Model: OR-C1	Date: 12-Sep-11	No.: RD120001c
--------------	-----------------	----------------

Subject: Firmware Release Note: Fax		Prepared by: J. Kitagawa	
From: 1st Tech Service Sect.MFP/Printer Tech Service Dept.,			
Classification:	<input type="checkbox"/> Troubleshooting <input type="checkbox"/> Mechanical <input type="checkbox"/> Paper path <input type="checkbox"/> Product Safety	<input type="checkbox"/> Part information <input type="checkbox"/> Electrical <input type="checkbox"/> Transmit/receive <input checked="" type="checkbox"/> Other (Firmware)	<input type="checkbox"/> Action required <input type="checkbox"/> Service manual revision <input type="checkbox"/> Retrofit information <input checked="" type="checkbox"/> Tier 2

This RTB has been issued to announce the firmware release information for the **Fax**.

20.Paper Invert Section (D120/D121/D122/D139/D140/D141)

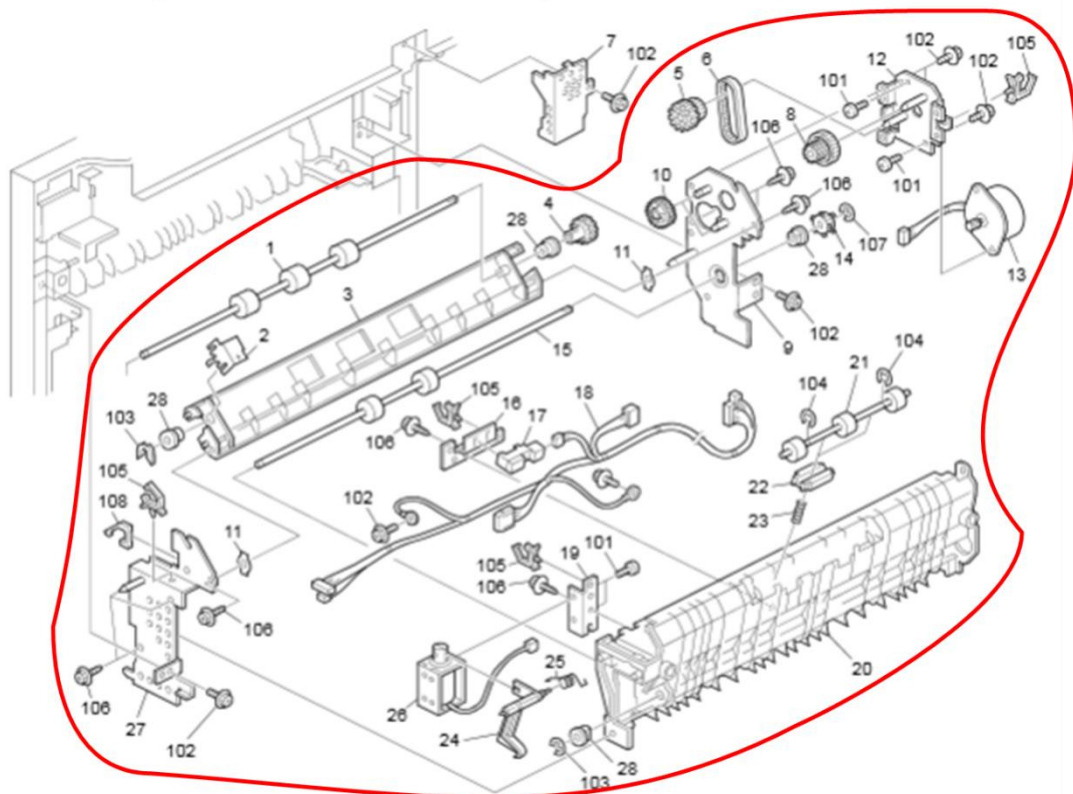
Change: The parts boxed in red in the illustration were registered as an assembly.

Reason: To meet requests from the field.

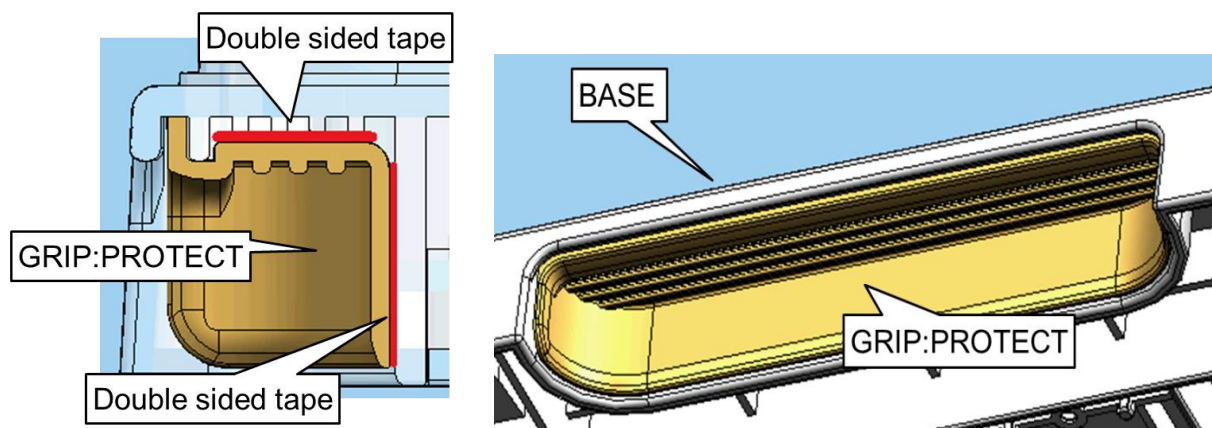
Model	Old part number	New part number	Description	Q'ty	Int	Page	Index	Note
LHOTSE-D	-	D5781991	GRIP:PROTECT:ASS'Y	0-1	-	3	27

Important: Attach the grip to the base using double-sided tape.

17.Fusing Unit 1 (D120/D121/D122/D139/D140/D141)

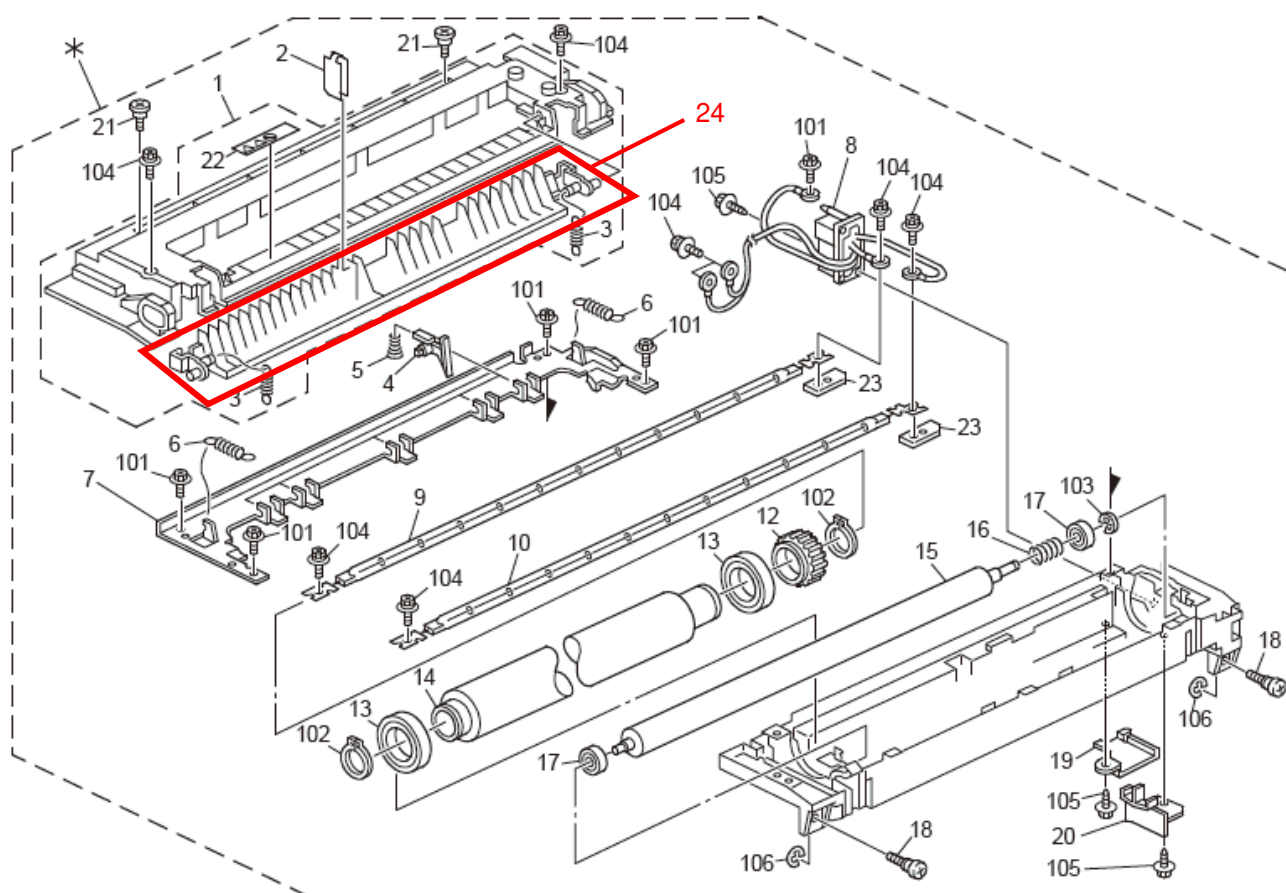
Change: The guide plate outlined in red was registered as a service part.

Reason: To meet requests from the field.

14.Toner Supply Unit (D120/D121/D122/D139/D140/D141)

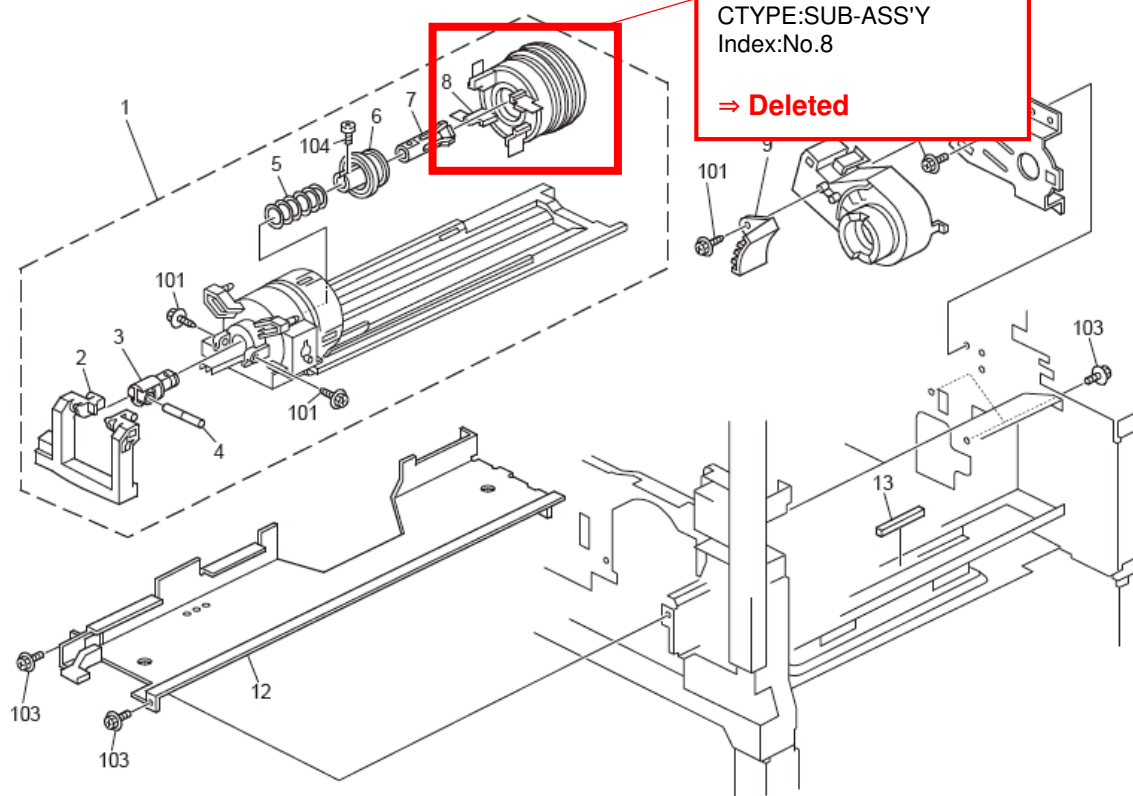
Change: The toner bottle cover was deleted from the parts catalog.

Note: Procure the assembly unit (p/n: D1203505) when required to replace the toner bottle cover.

21.Duplex Section 1 (D120/D121/D122/D139/D140/D141)

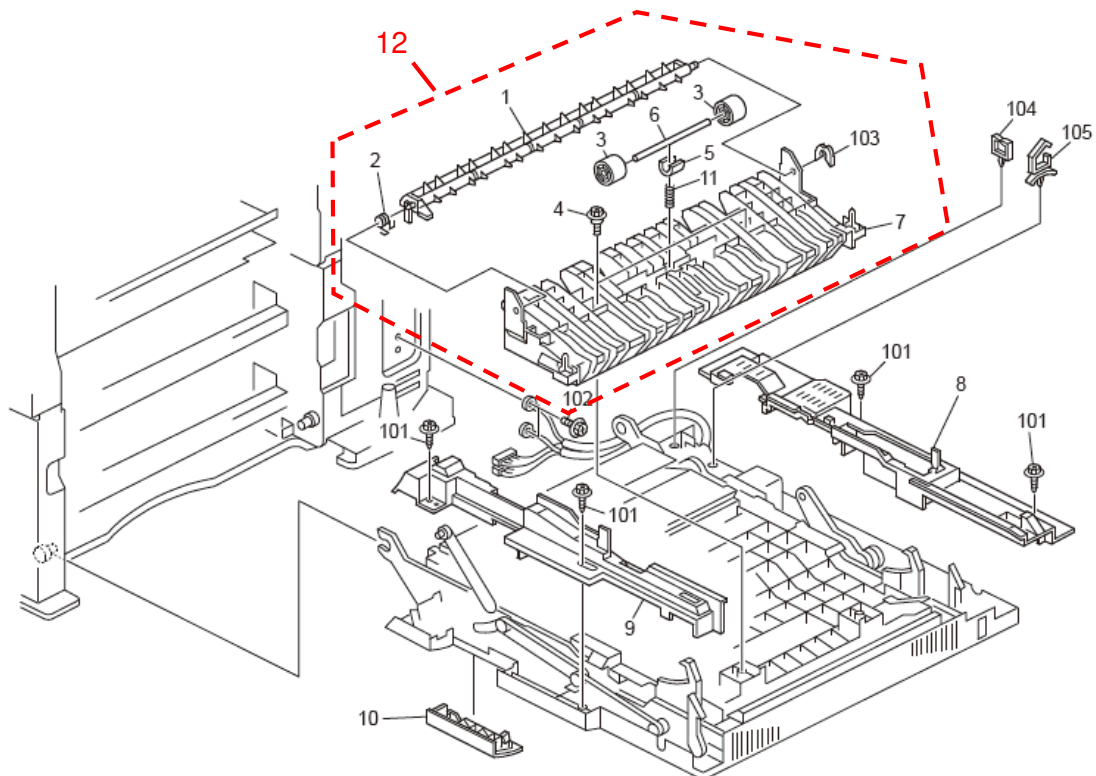
Change: Part number of the Guide Plate was added.

Old part number	New part number	Description	Q'ty	Int	Page	Index	Note
-	D1204674	GUIDE PLATE:GATE:ASS'Y	1		49	12

25.Duplex Section 5 (D120/D121/D122/D139/D140/D141)

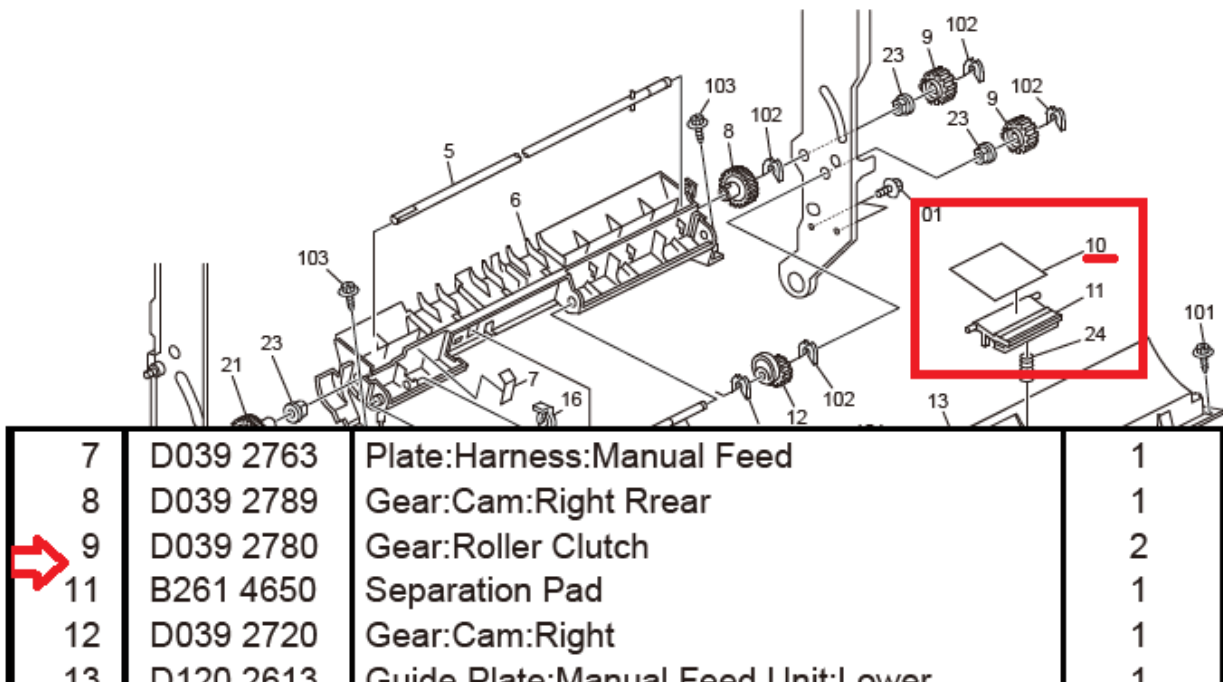
Parts Number of Duplex section 5, Item #10 isn't given in the Parts Catalog.
 The part number is **D1202614**.
 For the part number in the Parts Catalog, refer to the following figure.

#10 D1202614 (mylar)
